**V2500-A5/D5 PROPULSION SYSTEMS SERVICE BULLETIN**

This document transmits the Initial Issue of Service Bulletin EV2500-72-0376

**V2500-ENG-72-0376**  
Transmittal - Page 1 of 2

ENGINE - HP COMPRESSOR DISCS (STAGES 3 - 8) - INTRODUCTION OF A REVISED STAGE 3 - 8  
DISC ASSEMBLY WITH INCREASED LIFE

Family Tree - A5 and D5 Engines (Not including A533)  
Fig 1Oct.28/02  
Oct.28/02

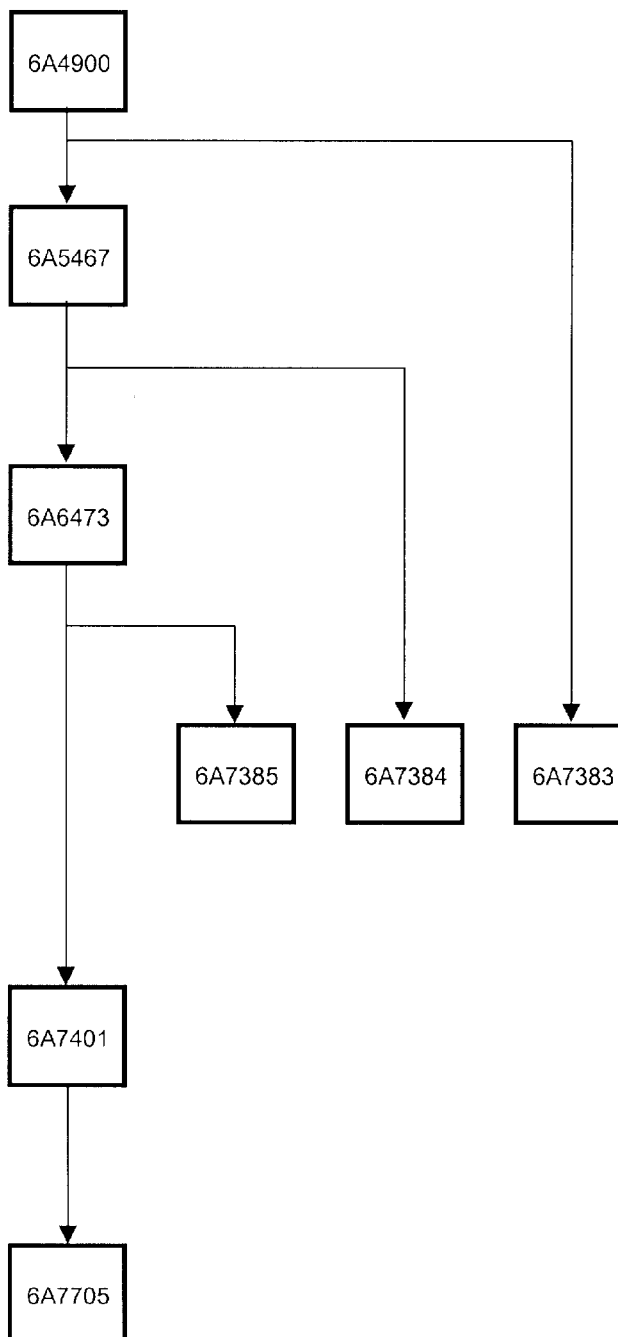
**V2500-ENG-72-0376**

Engine - HP Compressor Discs (Stages 3-8) - Introduction of a Revised Stage 3-8 Disc Assembly With Increased Life.

Family Tree - A533 Engines Only  
Fig 2

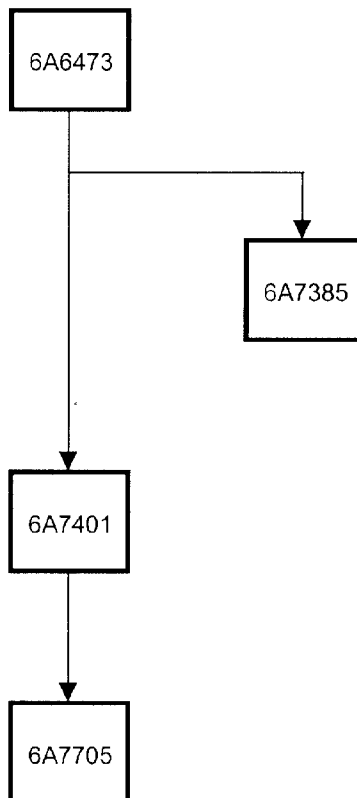
**V2500-ENG-72-0376**

Engine - HP Compressor Discs (Stages 3-8) - Introduction of a Revised Stage 3-8 Disc Assembly With Increased Life.
